OWNER NOTIFICATION CAMPAIGN

Service Advisory: 14-215

Keystone RV Company is conducting an owner notification campaign on certain 2015 Keystone Travel Trailers and Fifth Wheels. Although a very small percentage of vehicles are affected by this we want to bring this to your attention because your continued satisfaction is of the utmost importance to us.

Correct Track Cam Plate Locations

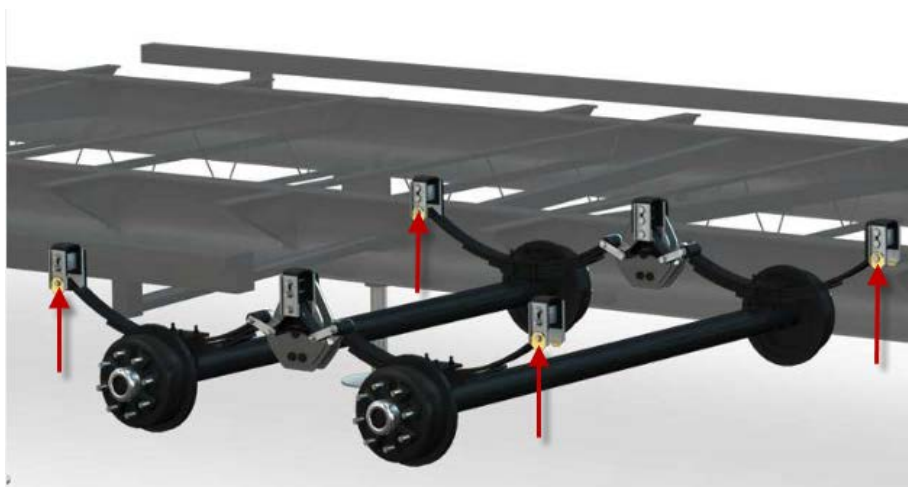
It has been determined that the octagon Correct Track cam plate on certain vehicles may have been manufactured out of specification. If the hanger has the defect part **and** the involved component **has been adjusted** from the original manufacturing setting, it may allow excessive suspension movement possibly causing abnormal wear of the suspension components or tires. The component, **as installed and not having been adjusted**, poses no safety problem and should be **inspected for the below condition** and replaced allowing adjustment in the future **should it be required**.

Inspect the inner and outer octagon Correct Track cam plates located on the front and rear axle spring hangers on both sides of the unit. Each unit has a total of eight (8) plates for tandem axle trailers and twelve (12) for triple axles. The correct measurement for the overall size of the plate is 3". Plates manufactured out of specification will be less than 3".
